Team Update 19

Team Update 18

Figure 3-17 Temporary SCALE lighting.

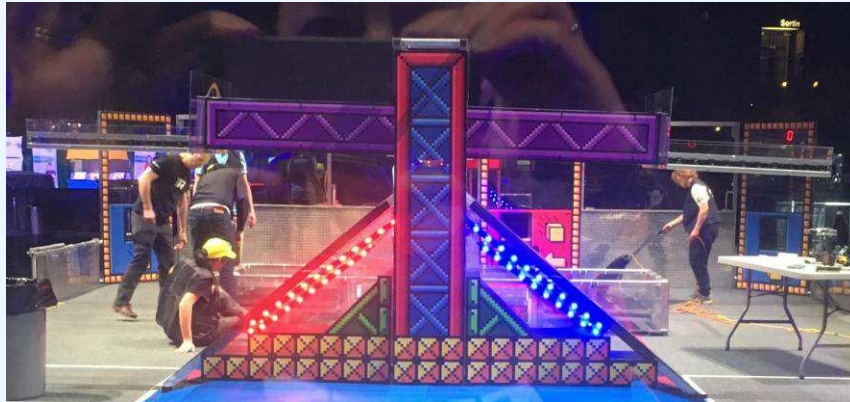
Until further notice, events are instructed to install the SCALE light strings in the cavity below the outriggers instead of around the PLATES, approximately as shown below.

Figure 3-19: Blue ALLIANCE VAULT

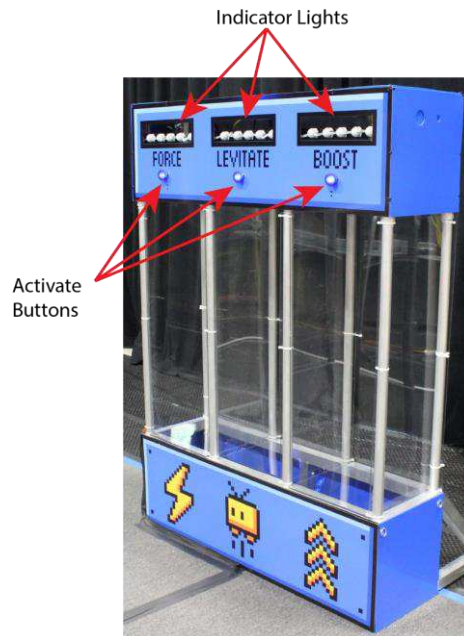
POWER CUBES placed logo-side-up may result in POWER CUBES not being sensed consistently by the FIELD.

Caution, there may be orientations where all three (3) POWER CUBES will not fit in a VAULT column, but if HUMAN PLAYERS place POWER CUBES logo side up **down** they'll fit with room to spare.

Figure 8-8: BUMPER support examples

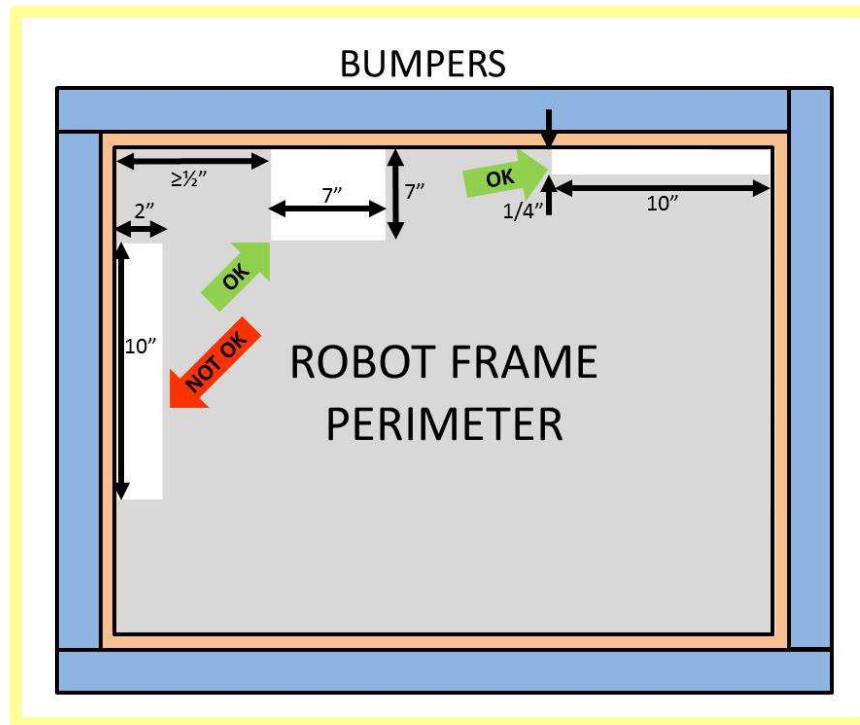
R32. BUMPERS must be supported by the structure/frame of the ROBOT (see Figure 8.8). To be considered supported, a minimum of ½ in. (~12.7 mm) at each end of each BUMPER wood segment must be backed by the FRAME PERIMETER (\leq ¼ in. gap). “Ends” exclude hard BUMPER parts which extend past the FRAME PERIMETER permitted by R30, part B. Additionally, any gap between the backing material and the frame:

- A. must not be greater than ¼ in. (~6 mm) deep, or
- B. not more than 8 in. (~20 cm) wide

Example 1: A ROBOT may not hold the SCALE PLATE in a “balanced” state.

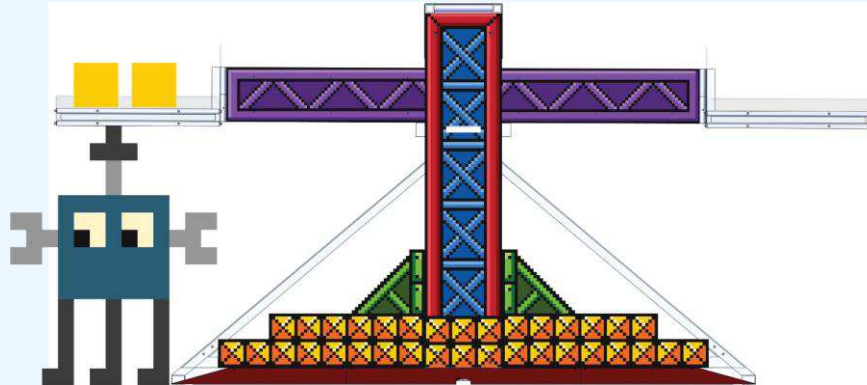
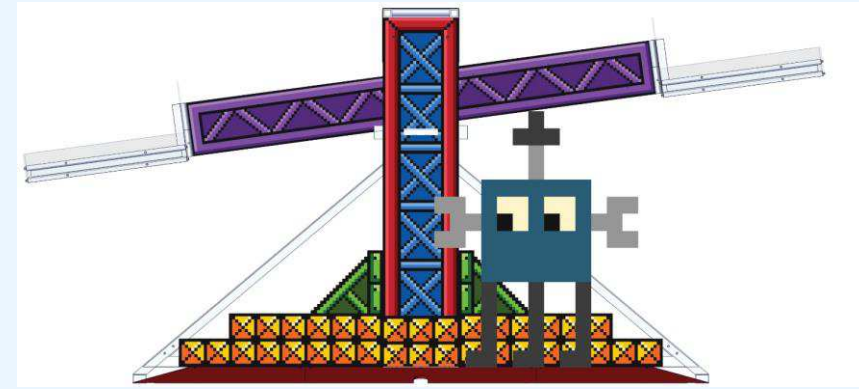
The intent of G25 is to make it clear that PLATES are to move solely because of POWER CUBE weight and not because of a ROBOT deliberately trying to move PLATES (either by using its own manipulator, or a POWER CUBE as an extension of the ROBOT, to push or hold a PLATE).

The “momentary” and “minimal” language in G25 is subjective but necessary because ROBOTS may cause PLATE movement (or prevent PLATE movement) as they place POWER CUBES and bump PLATES, get hit, etc.

Generally, “momentary” means near instantaneous, or in other words, contact for less than approximately one (1) second and “minimal” means a displacement of fewer than approximately three (3) in. However, REFEREES are not expected to measure, and be accountable to, real-time PLATE displacement or precise timing from their vantage points.

Figure 3-14: SWITCH PLATE dimensions

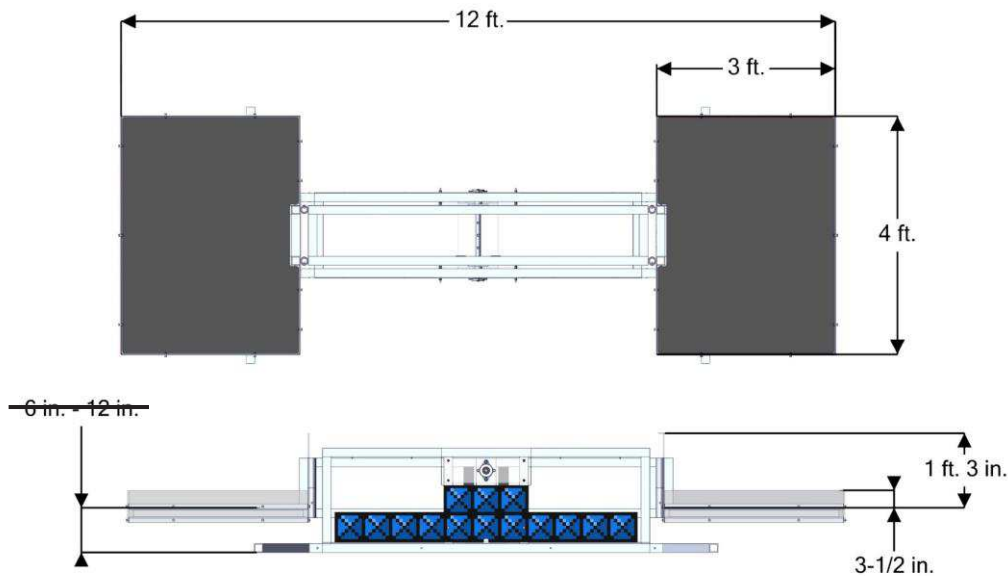
Figure 3-14 has been updated to remove the lower left dimension, which doesn't add value.
